## Mack Chassis - Hood Mirror Vibration - Model AN

A product improvement has been made to the Mack Anthem Hood Mirror. The supplier has reinforced the mirror glass carrier backing to make it more robust by filling in the tabs as seen below. The component material has changed from ASA to ABS plastic. This improvement affects Mack Anthem trucks, built from January 1, 2018 thru May 24, 2021.

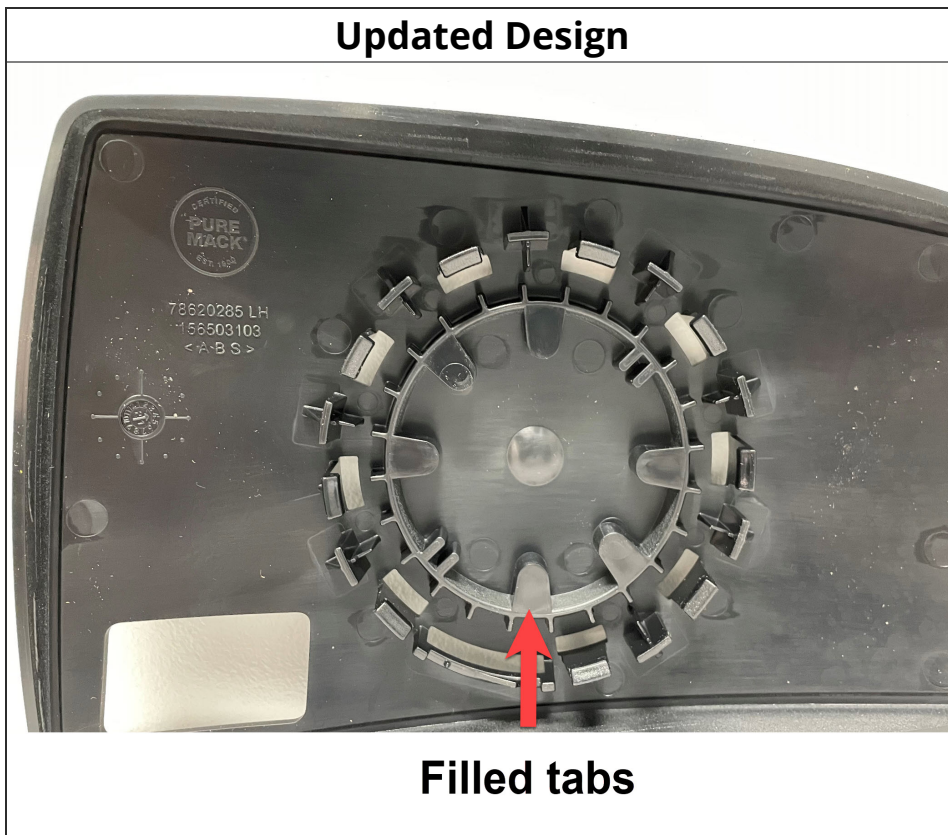
**NOTE:** All mirror glass carrier assemblies are manufactured as heated. If the truck does not have the heated mirror option, simply ignore the electrical contacts. See the electrical contacts in the illustration below.
